Subject: Ryan Field Redevelopment at Northwestern University
Rebuttal to Arup responses dated September 27, 2023 and Steven Harper Presentation

The following are responses to the Arup Memorandum (Ryan Field Redevelopment at Northwestern University – Review of WJHW Rebuttal to Arup) dated September 27, 2023. The intent is to provide a response to the comments presented by Arup regarding our rebuttal of the information presented in their Memoranda dated August 11 and August 15, 2023.

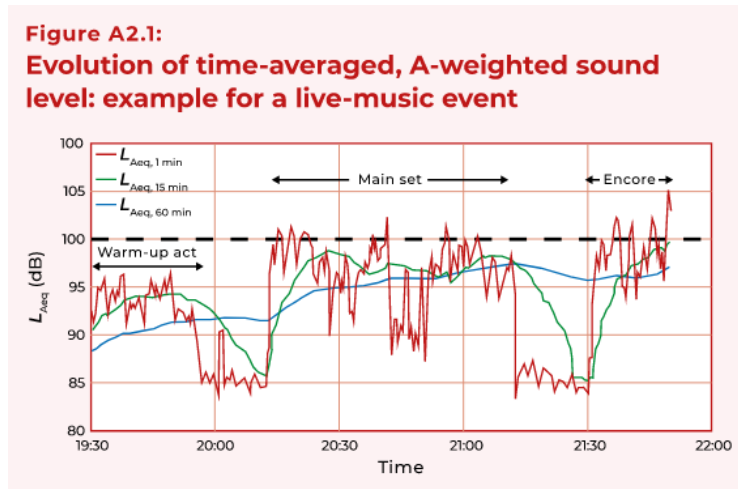
WJHW Response: *The reference to peak concert levels was to note that while the sound modelling is based on 101 dBA, the sound levels for the*

duration of a concert will not consistently be at 101 dBA. Figure A2.1: Evolution of time-averaged, A-weighted sound level: example for a live-music event from the WHO Global standard for safe listened venues and events, demonstrates how the sound levels can vary throughout the duration of a concert.

Figure 6: Concert Environmental Assessment Results with Additional Sound Mitigation (dBA)

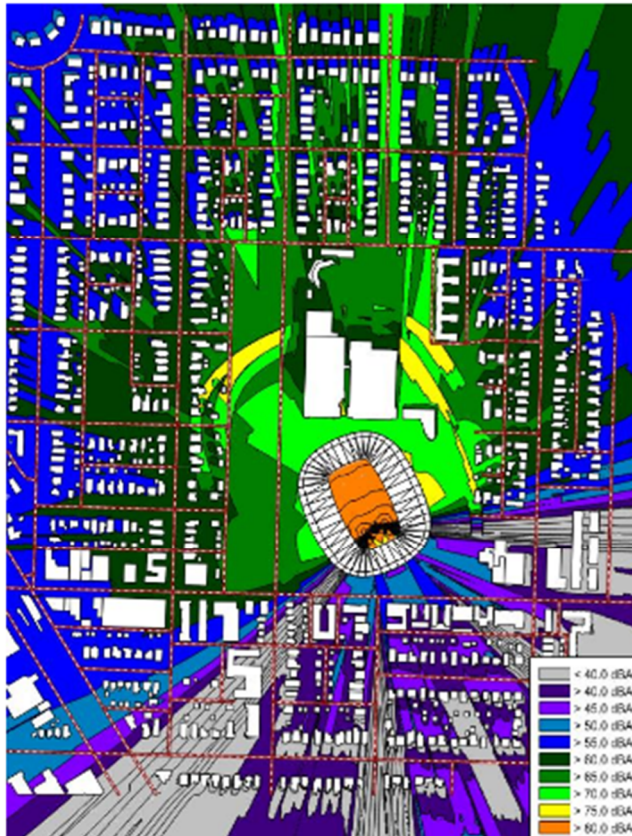
- The map Mr. Harper references is the “unmitigated” sound contour map (Figure 4, WJHW report dated August 2, 2023). The appropriate contour map is Figure 6 which shows the sound contours with the temporary (additional) sound mitigation. This map shows a clear improvement of sound transmission to the north and northwest of the stadium with lower sound impact on the residential properties.
